Access Compliance Report

Public Rights-of-Way

Intersection ID: 5236	Main Street: COPPALA_DR	Cross Street: KORNIV_DR	Location: NW
ADA ID: C44572840EC7	Ramp Type: PerpDiag	Initial Pass/Fail: Fail	Overall Compliance: No
		Severity Score: 25

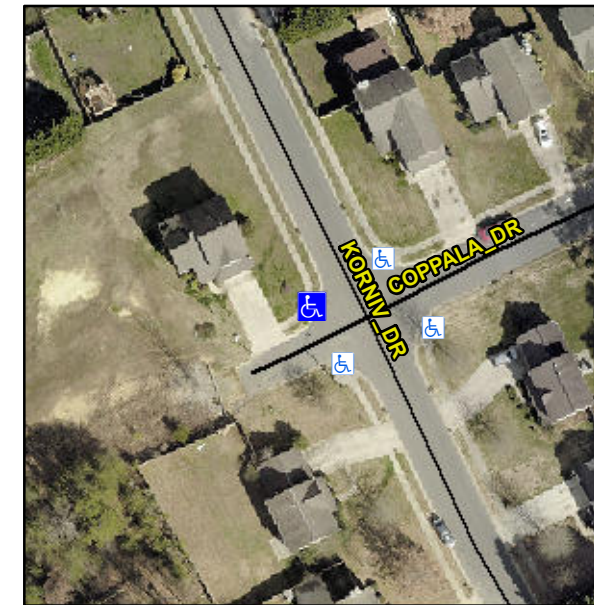
Compliance	Description	Data	Compliance	Description	Data
N/A	Ramp Length (in)	46.0	Yes	Ramp Slope (%)	5.4
Yes	Ramp Width (in)	49.0	No	Ramp XSlope (%)	9.5
N/A	Flare Type LT	N/A	N/A	Flare Type RT	N/A
N/A	Flare Slope LT (%)	N/A	N/A	Flare Slope RT (%)	N/A
N/A	Flare Traversable LT?	N/A	N/A	Flare Traversable RT?	N/A
N/A	Landing Length (in)	N/A	N/A	DWS Provided?	N/A
N/A	Landing Width (in)	N/A	N/A	DWS Contrast?	N/A
N/A	Landing Slope (%)	N/A	N/A	DWS Length (in)	N/A
N/A	Landing X Slope (%)	N/A	N/A	DWS Full Width?	N/A
N/A	Landing Curb? (Y/N)	N/A	N/A	DWS Offset (in)	N/A
N/A	Shared Landing?	N/A			
N/A	Gutter Ponding?	N/A	N/A	Gutter Slope (%)	N/A
N/A	Gutter Lip Ht (in)	N/A	N/A	Gutter X Slope (%)	N/A
N/A	Painted X Walk1?	No	N/A	Painted X Walk2?	No
	X Walk 1 Direction	To S		X Walk 2 Direction	To E
N/A	X Walk 1 Width (in)	N/A	N/A	X Walk 2 Width (in)	N/A
	X Walk 1 Slope (%)	7.1		X Walk 2 Slope (%)	0.1
	X Walk 1 X Slope (%)	2.4		X Walk 2 X Slope (%)	6.7

Remove & Replace Curb Ramp With Two New Directional Ramps or Equivalent.
